**THE
NATIONAL
BOARD**
OF BOILER AND
PRESSURE VESSEL
INSPECTORS

NATIONAL BOARD SUBGROUP HISTORICAL BOILERS

MEETING MINUTES

Meeting of January 11th, 2016
Corpus Christi, TX

FIGURE S2.13.12.3
TUBESHEET FLUSH PATCH

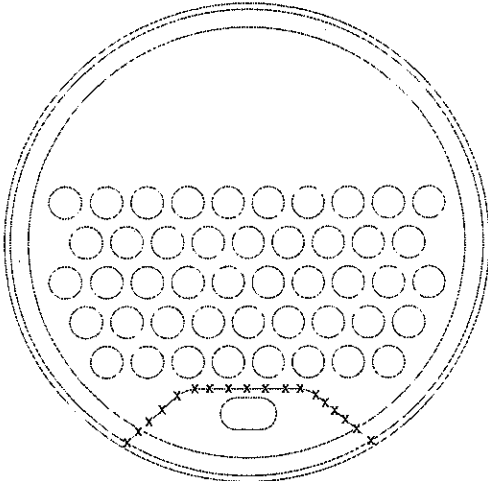
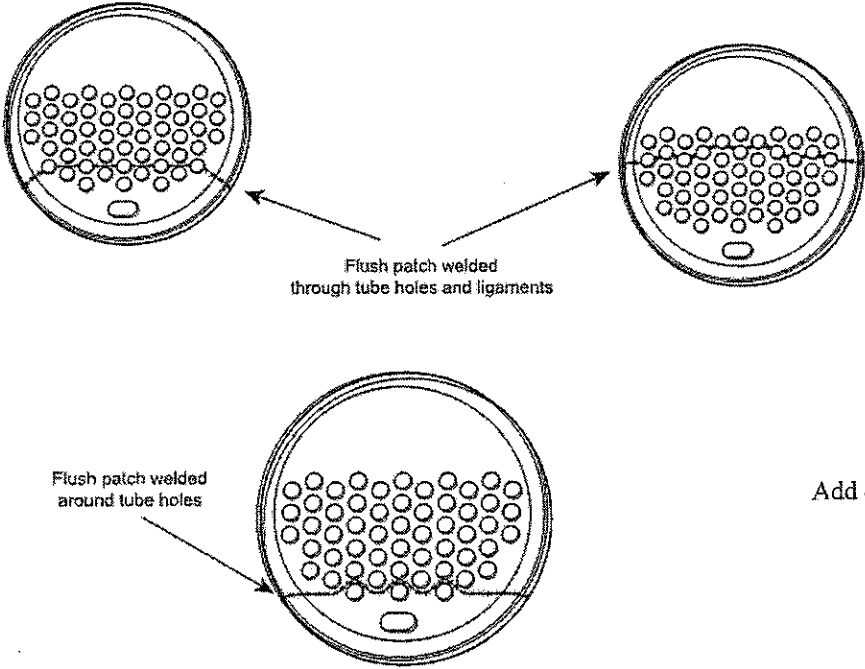
2. Update Figure S2.13.12.3

Add a 4th diagram to figure S2.13.12.3 to show a tube sheet repair, which encompasses the hand hole opening area, however doesn't extend through the tube area.

Add 4th diagram here

FIGURE S2.13.12.3.A
Front Tubesheet Repair

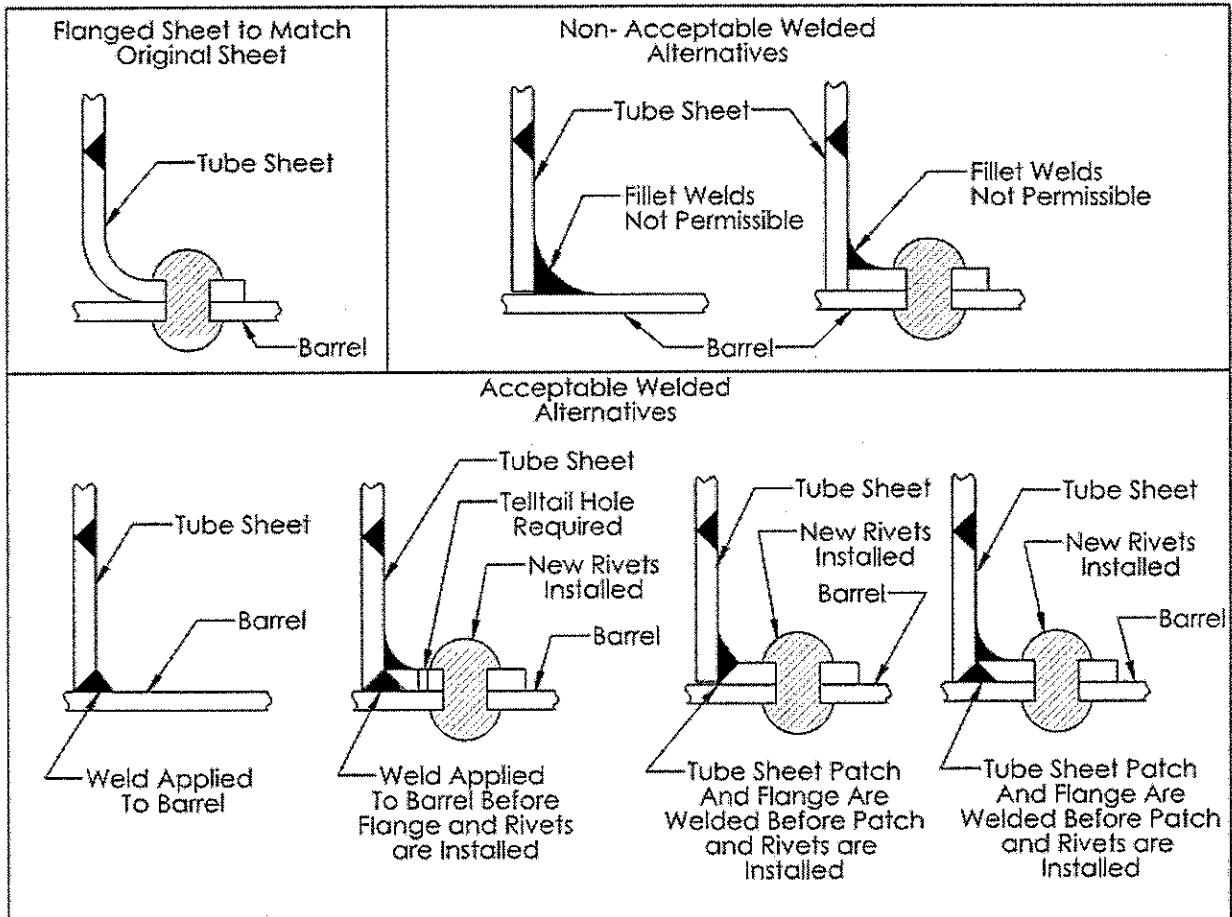
- 2) A flush patch repair can be welded through tube holes or around tube holes. (See NBIC Part 3, Figure S2.13.12.3)
- 3) If the Flush Patch repair extends through the tube sheet radius either the sheet should be flanged to match the original tube sheet flange or a welded alternative may be used as shown in NBIC Part 3, Figure S2.13.12.3.A

3. Add Figure S2.13.12.3A

Add figure S2.13.12.3a to show acceptable and non-acceptable tube sheet repair methods.
